# Input for HEV power determination

## From Japan

guidance material on intake manifold and fuel flow rate

Figure 5.40 Intake pipe pressure and HEV system power output of testing vehicle A

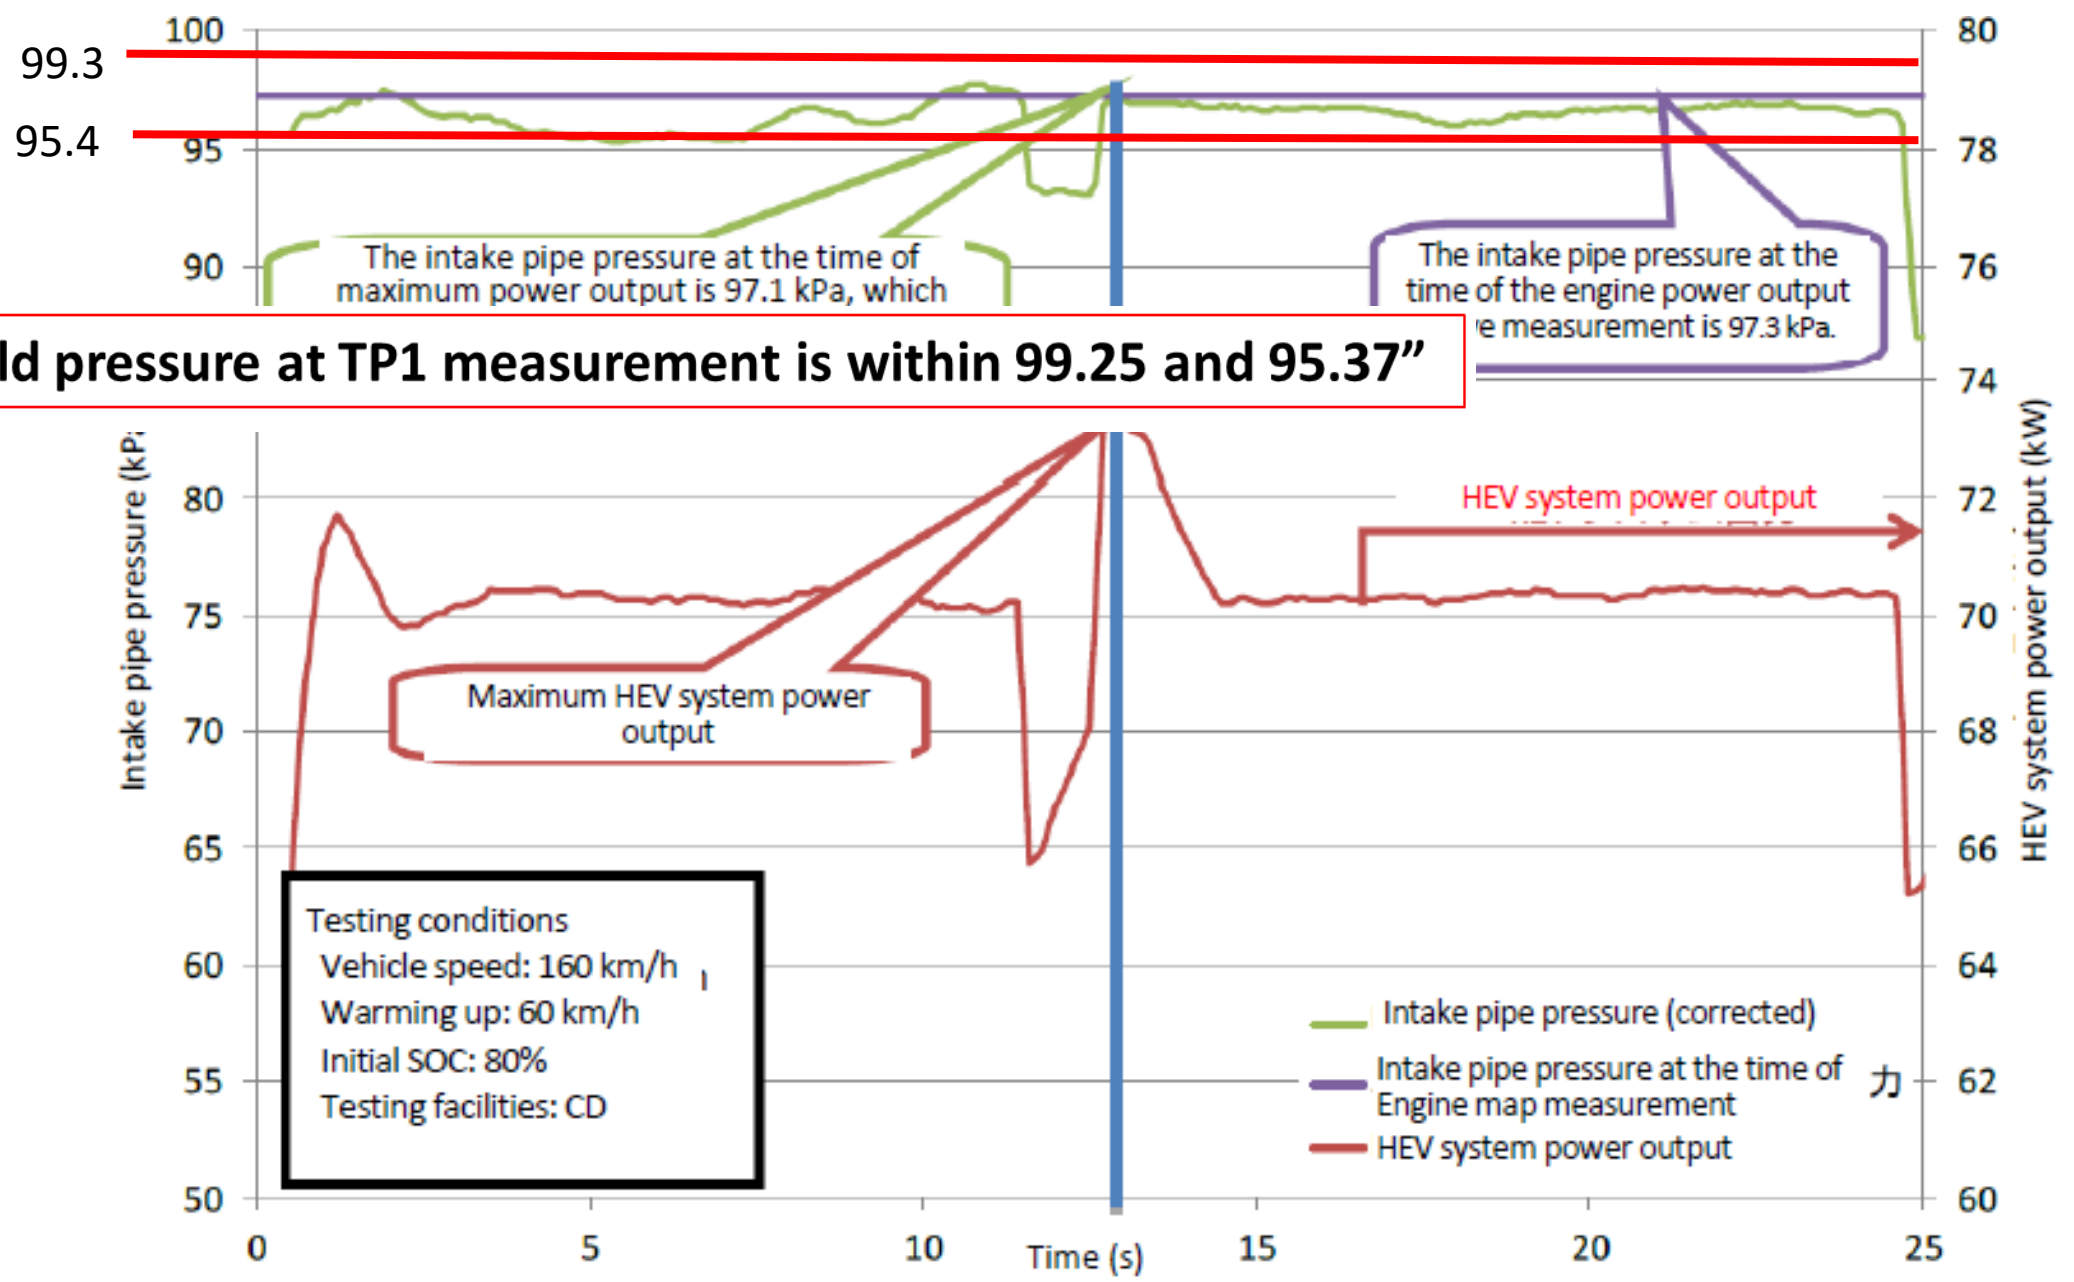
“intake manifold pressure at TP1 measurement is within 99.25 and 95.37”
